5/14/2009

Enclosed please find my comments for the Group 5 Resource Conservation Recovery Act Facility Investigation (Group 5 RFI Report) representing the results of contamination and debris in the AREA III & AREA IV portions of the Santa Susana Field Laboratory (SSFL).

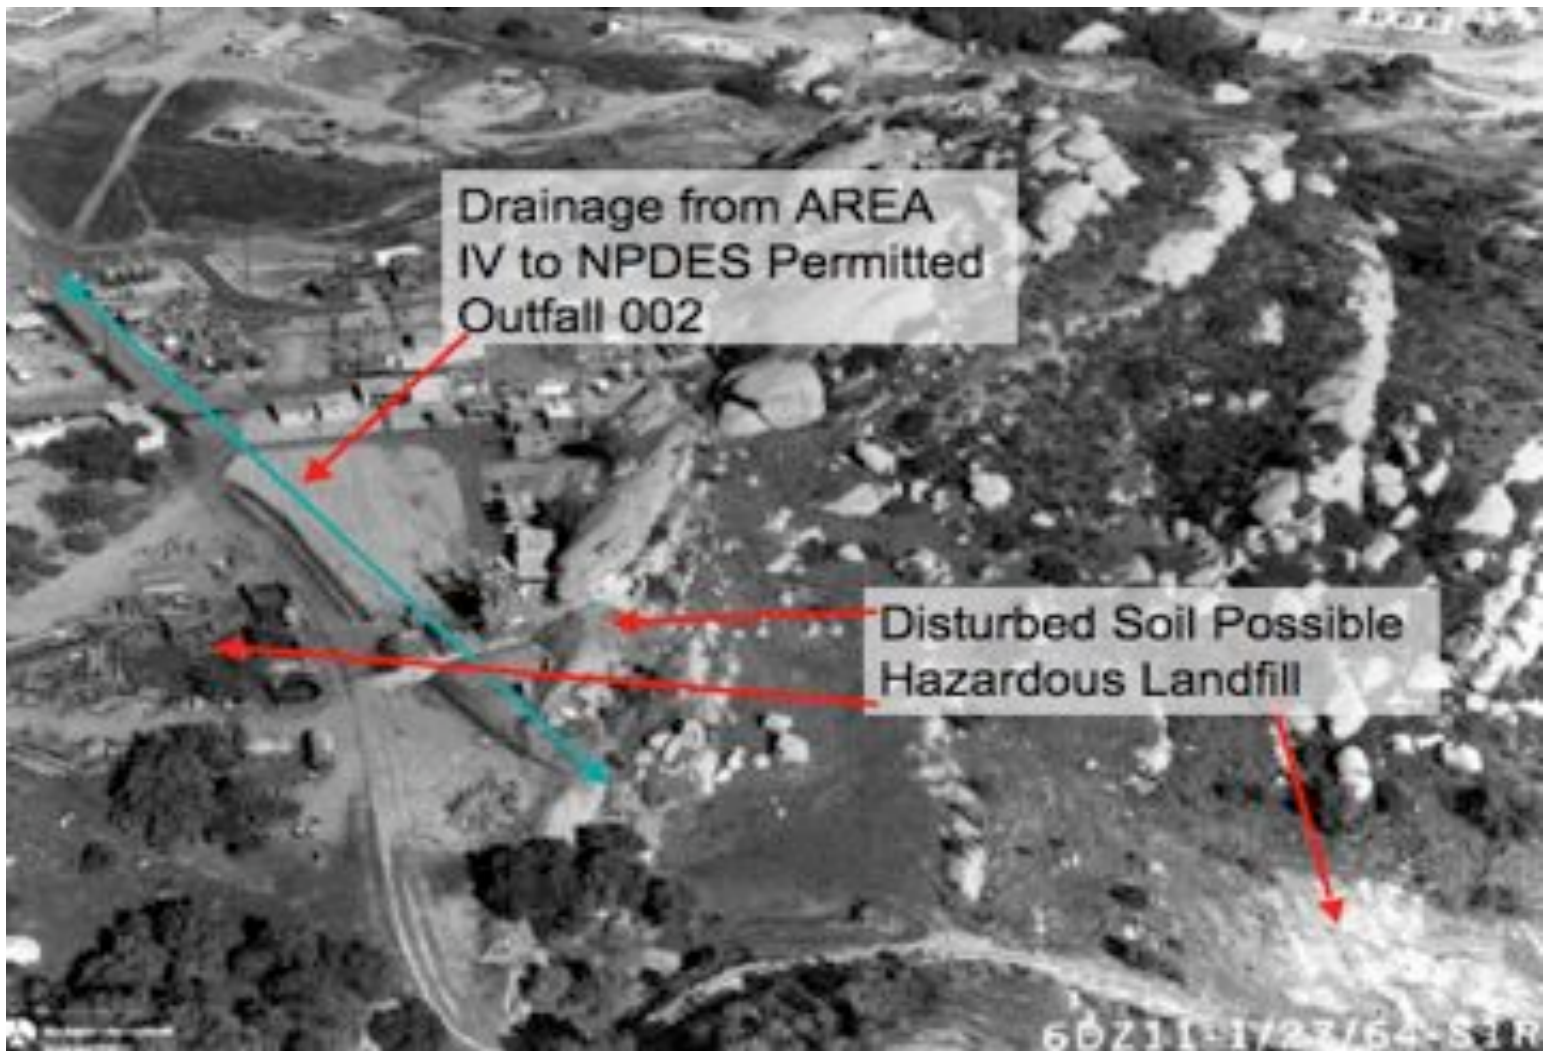
The CTL IV ROAD just below the facility to the south is a direct connection to the AREA I Burn Pit. After blaming dials in a November 2008 discovery of Radium in the AREA I Burn Pit, did the responsible parties properly transport & dispose of the dials from CTL IV? Was the Public at Risk as they removed this facility before adequate sampling was completed?

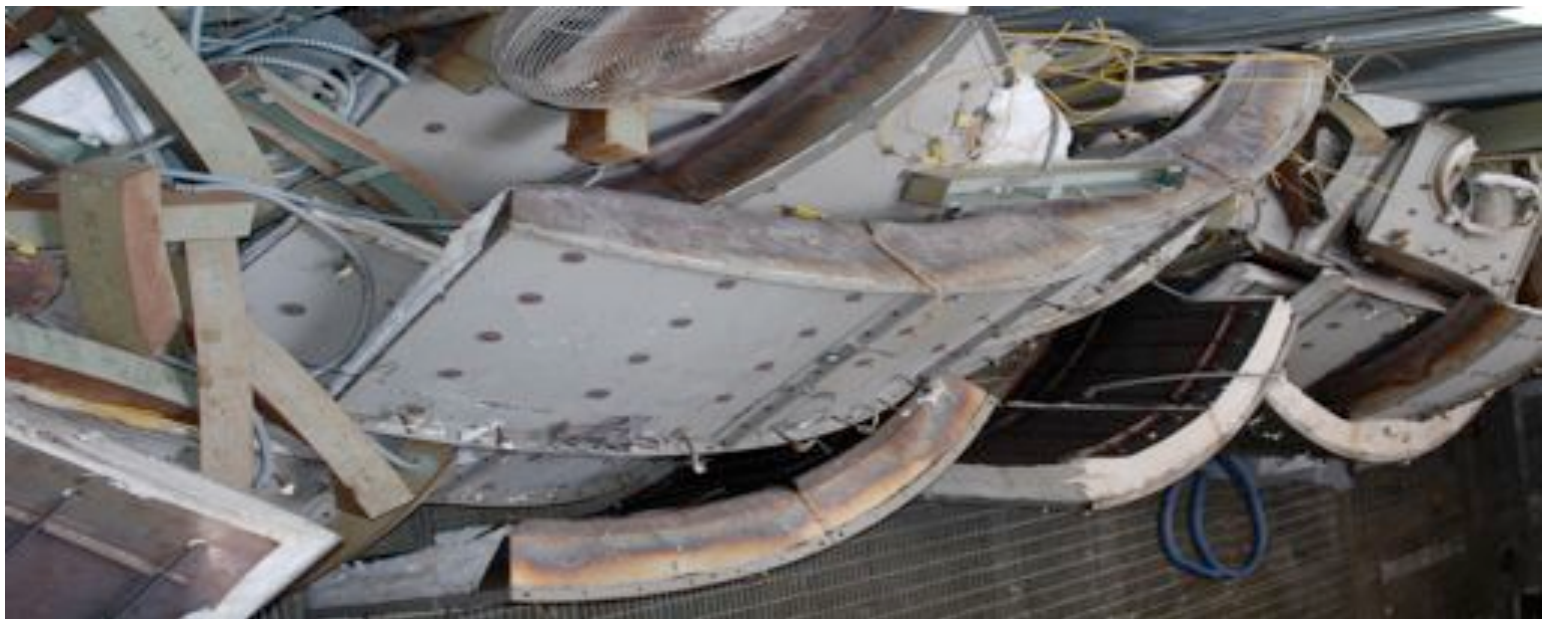
The area above labeled as Drum Storage is located to the east of Building 4012 and should be included in this investigation. Do we know all the chemicals used in these areas? Are we doing enough sampling to ensure public safety? This should be top priority. Keep in mind this was primarily the Nuclear area of the Santa Susana Field Laboratory. High concentrations of Alcohol were found in past sampling in the soil & groundwater. When Alcohol is found around a former Nuclear Reactor, there are concerns. Please link to the below report...

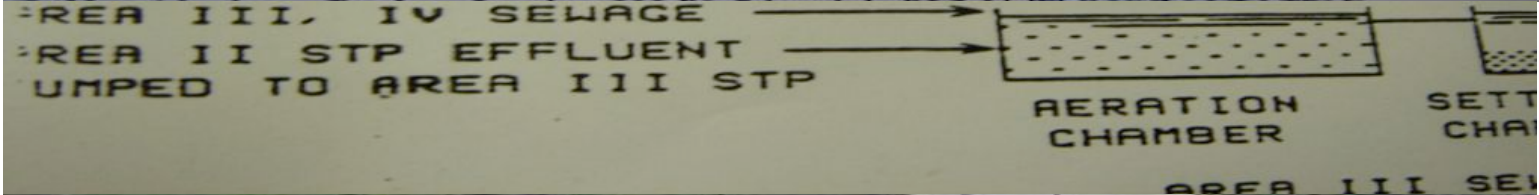
Parking lot (4520) of the Rockwell International Hot Lab. As you can see from the above photo SAMPLING IS NEEDED as it was used for Hazardous Waste Interim Storage as the RIHL was being demolished. The recommendations of CH2M Hill (Boeing & DOE Contractor) Not to Sample this parking lot is a potential for leaving harmful toxins in the ground. Rain after rain will then wash these toxins into the R-2 Pond and overflowing into the Los Angeles River via Bell Creek. With the removal of all buildings in the northern area of CTL/STL IV in AREA III the runoff from this parking lot will have a more direct pathway to the R-2 pond in AREA II that will potentially impact the Los Angeles River.

Photograph – Building 4363

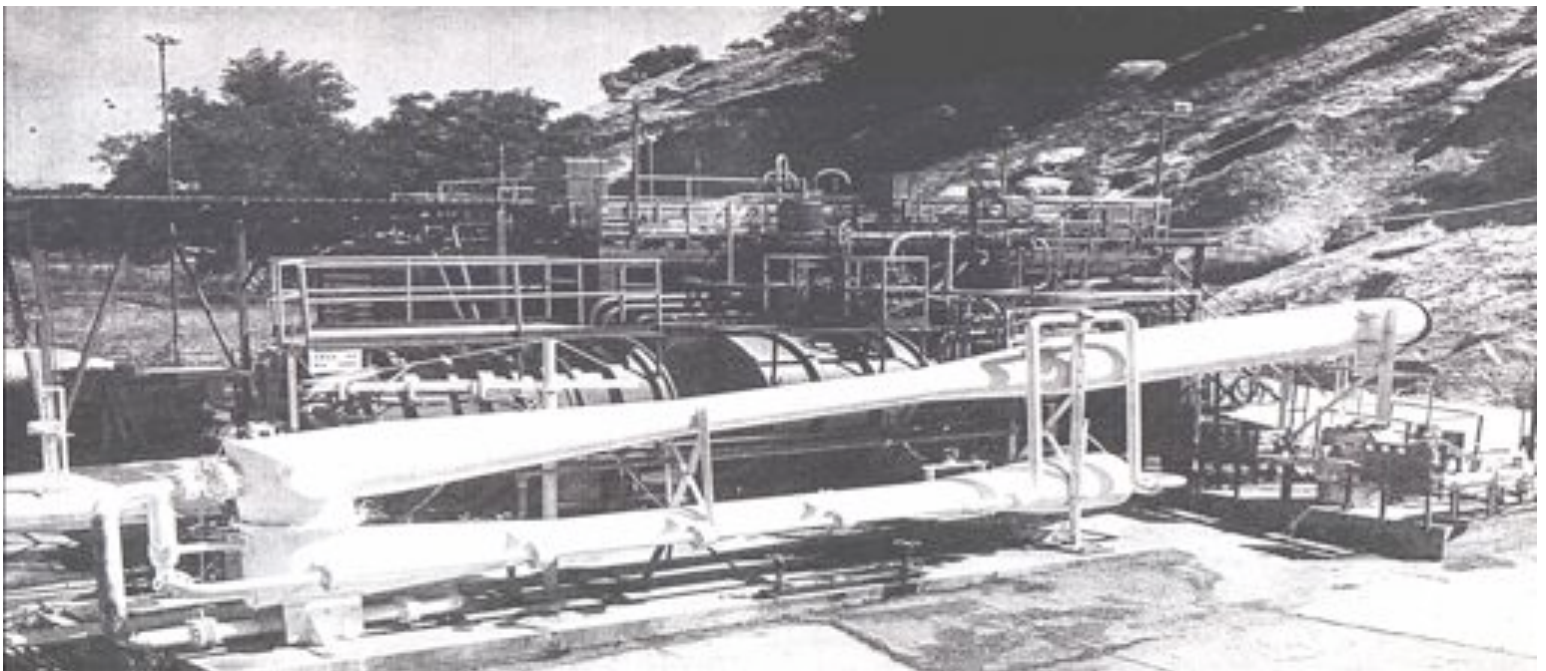
The Locations of former Well Heads and Manhole Covers such as the small concrete square shown above at the Building 4363 Sidewalk. With many of these buildings torn down we have to spread out with a larger grid of sampling & analysis.
